15V-613(FL-691, 15R2, 15R3)

SAFETY RECALL BULLETIN

November 2015
15R-2 (FL-691)
NHTSA #15V-613
Transport Canada #15-485

Subject: **Detroit Axle Steering Arm Capscrew Inspection**

Figure 1 – Steering Arm Capscrew Location

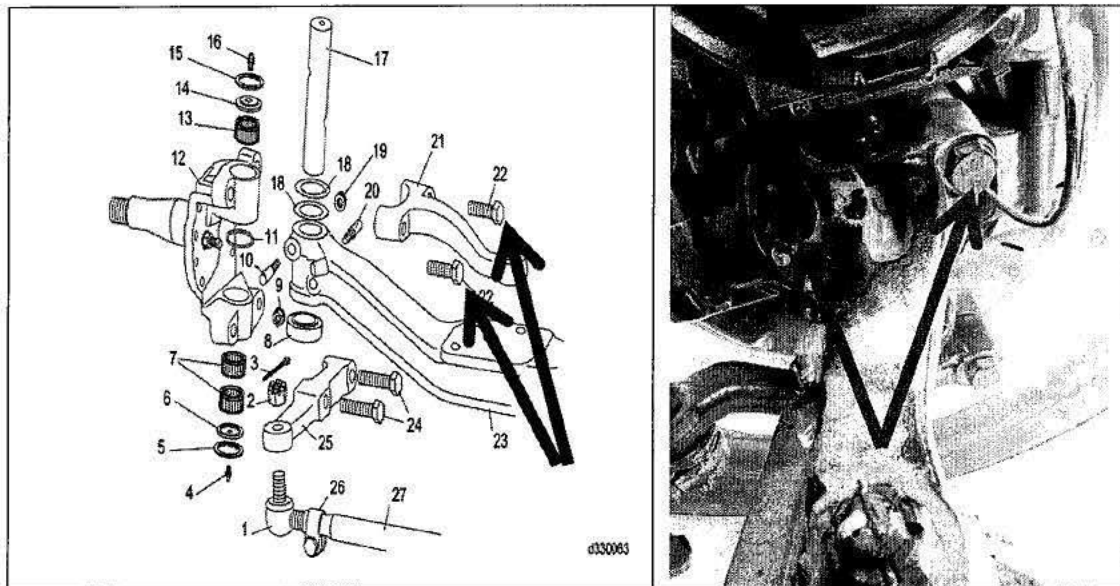
2. Apply the parking brake, turn off the ignition, chock the rear wheels, disconnect the batteries, and perform any other applicable safety steps.
3. Using a suitable torque wrench, check the torque on the two steering arm capscrews. See Figure 1.
 - a. For Model 2 and Model 3 axles with a M20 capscrew, correct torque is 425 lbf-ft (575 Nm).
 - b. For Model 5 axles with a M24 capscrew, correct torque is 664 lbf-ft (900 Nm).

Figure 2 – Damaged Joint Surfaces

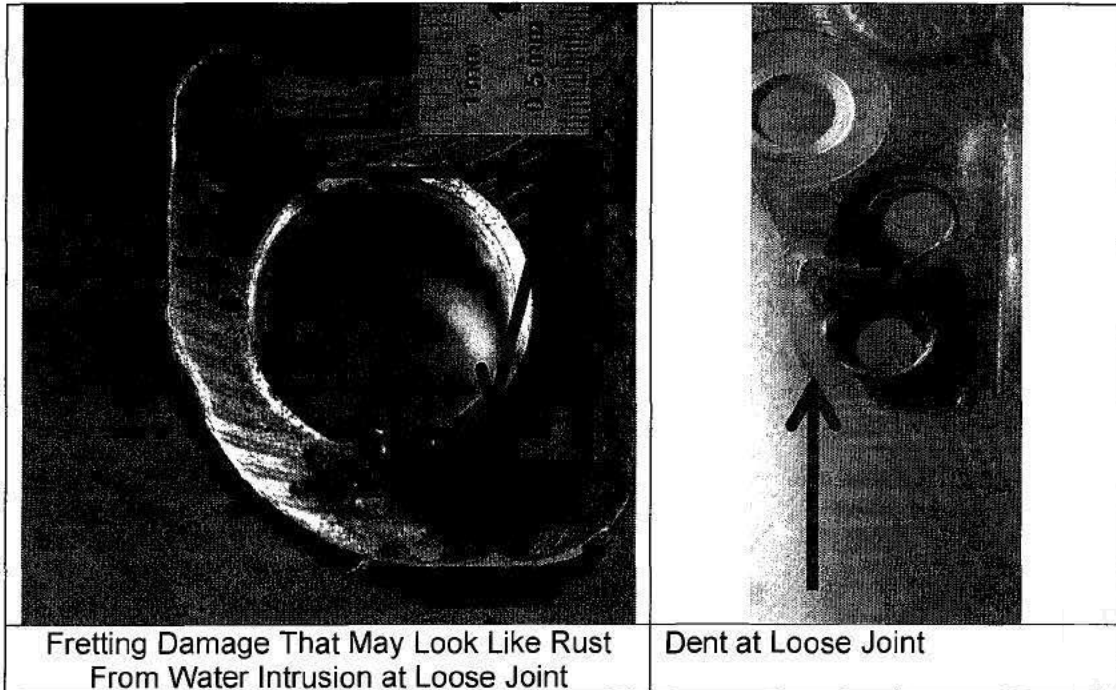
6. Inspect the joint surface between the steering arm and steering knuckle for signs of fretting, dents, or other damage from the loose capscrew(s). See Figure 2 for examples of damaged parts, and Figure 3 for an example of a new part.

7. Are the joint surfaces of either the steering arm or steering knuckle damaged?
 - a. If Yes, then proceed to step 8.
 - b. If No, then proceed to step 10.

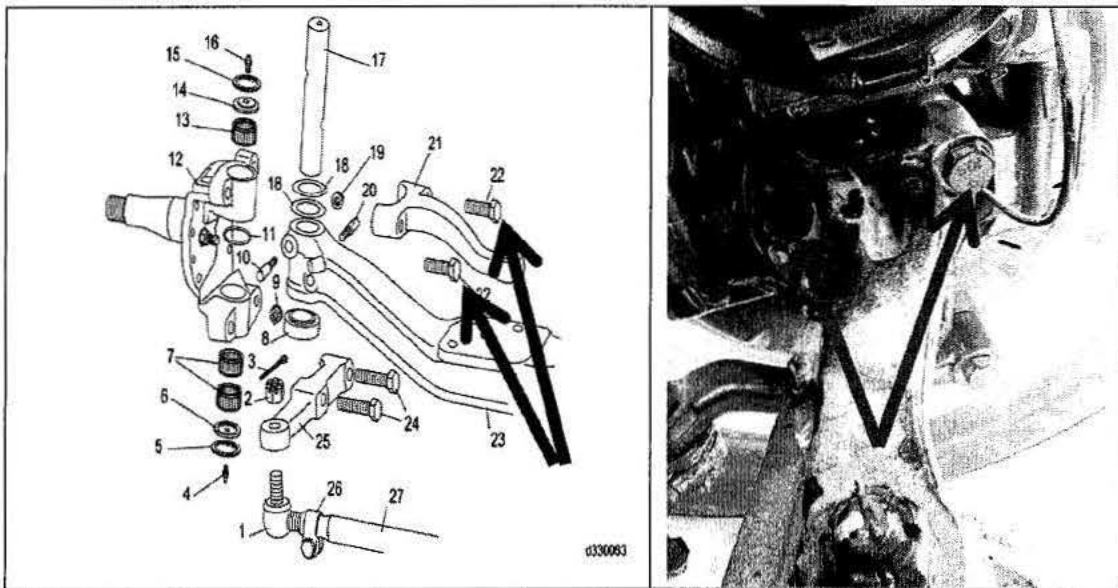
1. Park the vehicle in the designated repair area and turn the steering wheel all the way to the left to expose the steering arm on the driver's side of the vehicle.
2. Apply the parking brake, turn off the ignition, chock the rear wheels, disconnect the batteries, and perform any other applicable safety steps.
3. Remove the two steering arm capscrews, and remove the steering arm.
Reference section "Dissassembly of the Steering Knuckle" in the Front Axles chapter of the *Detroit Axles Manual* (DDC-SVC-MAN-0141). See Figure 1.

Figure 2 – Damaged Joint Surfaces

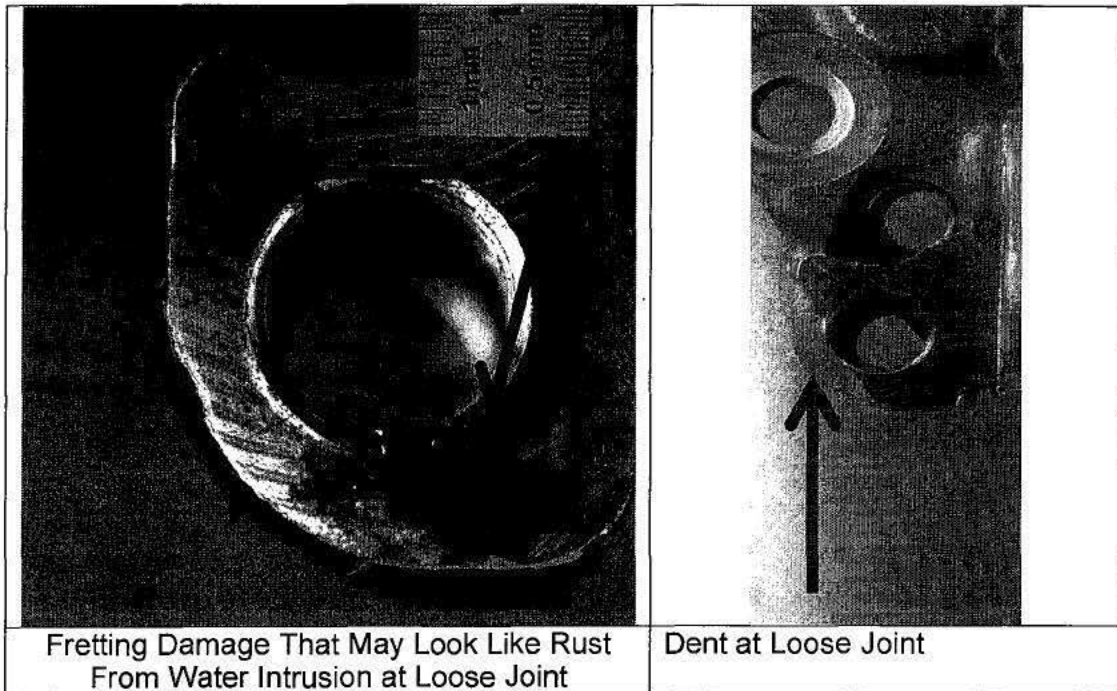
4. Inspect the joint surface between the steering arm and steering knuckle for signs of fretting, dents, or other damage from the loose capscrew(s). See Figure 2 for examples of damaged parts, and Figure 3 for an example of a new part.

5. Are the joint surfaces of either the steering arm or steering knuckle damaged?
 - a. If Yes, then proceed to step 6.
 - b. If No, then proceed to step 8.
